Access Compliance Report

Public Rights-of-Way

Intersection ID: 10022823	Main Street: CASTLE_WATCH_AV	Cross Street: N/A	Location: SW
ADA ID: 4A0ADAF0E5CA	Ramp Type: PerpDiag	Initial Pass/Fail: Fail	Overall Compliance: No
Severity Score: 22.5			
Codes/Mitigation Info/Possible Solution		Field Measurements/Component Compliance

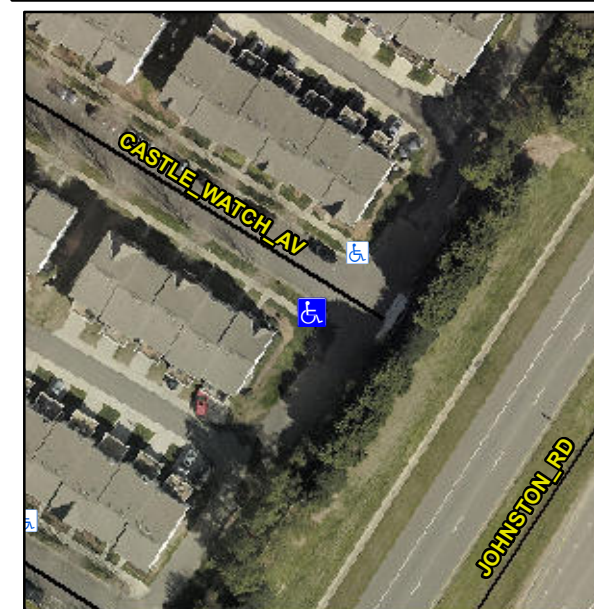
R304.5.1, R304.2.2, R304.5.3

Compliance	Description	Data	Compliance	Description	Data
N/A	Ramp Length (in)	78.0	No	Ramp Slope (%)	9.5
No	Ramp Width (in)	46.5	No	Ramp XSlope (%)	2.6
N/A	Flare Type LT	N/A	N/A	Flare Type RT	N/A
N/A	Flare Slope LT (%)	N/A	N/A	Flare Slope RT (%)	N/A
N/A	Flare Traversable LT?	N/A	N/A	Flare Traversable RT?	N/A
N/A	Landing Length (in)	N/A	N/A	DWS Provided?	N/A
N/A	Landing Width (in)	N/A	N/A	DWS Contrast?	N/A
N/A	Landing Slope (%)	N/A	N/A	DWS Length (in)	N/A
N/A	Landing X Slope (%)	N/A	N/A	DWS Full Width?	N/A
N/A	Landing Curb? (Y/N)	N/A	N/A	DWS Offset (in)	N/A
N/A	Shared Landing?	N/A			
N/A	Gutter Ponding?	N/A	N/A	Gutter Slope (%)	N/A
N/A	Gutter Lip Ht (in)	N/A	N/A	Gutter X Slope (%)	N/A
N/A	Painted X Walk1?	No	N/A	Painted X Walk2?	No
	X Walk 1 Direction	To NE		X Walk 2 Direction	To SE
N/A	X Walk 1 Width (in)	N/A	N/A	X Walk 2 Width (in)	N/A
	X Walk 1 Slope (%)	0.9		X Walk 2 Slope (%)	1.5
	X Walk 1 X Slope (%)	1.0		X Walk 2 X Slope (%)	1.5

Remove & Replace Curb Ramp With Two New Directional Ramps or Equivalent.
